NL-13-015

SUBJECT: Proposed License Amendment Regarding Connection of Non Seismic Boric Acid Recovery System to the Refueling Water Storage Tank
Indian Point Unit Number 2
Docket No. 50-247
License No. DPR-26

ANALYSIS OF PROPOSED TECHNICAL SPECIFICATION CHANGE
REGARDING CONNECTION OF NON SEISMIC BARS
TO REFUELING WATER STORAGE TANK

DWG. NO. 9321-F-2735	MY
----------------------	----

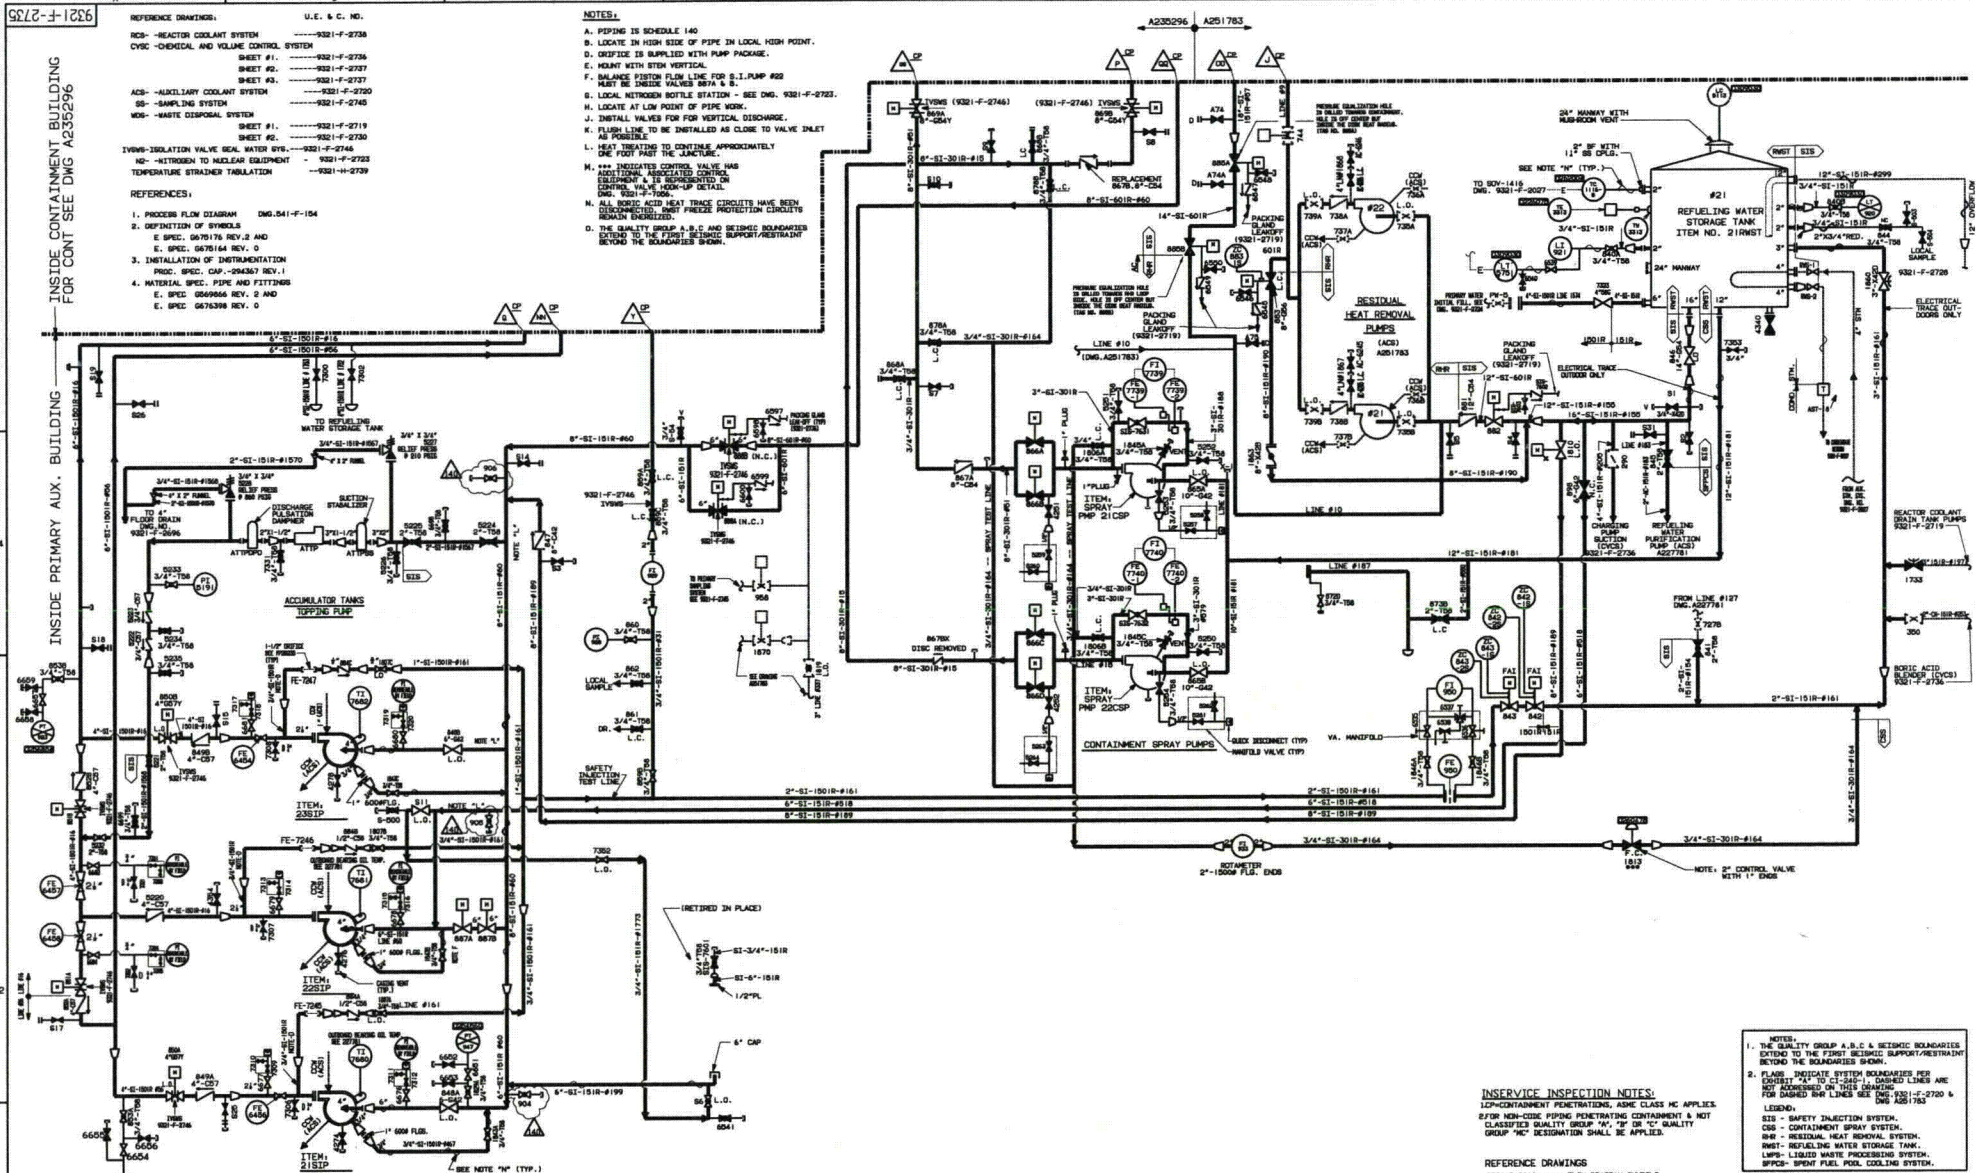
- The BARS suction line is connected to Valve 725 (see Drawing A227781, quadrant F-1 in the Enclosure) on the discharge to the Refueling Water Purification Pump (RWPP) by removing the valve bonnet and valve internals and installing a hose adapter plate.
- The BARS discharge line is connected to 2 inch line #252 upstream of 2 inch valve 350 (see Drawing 9321-F-2736, quadrant E-3 and Drawing 9321-F-2735 (valve 350 only),

quadrant I-4 in the Enclosure) by removing the 2"-150 psig flange and installing a hose adapter plate.
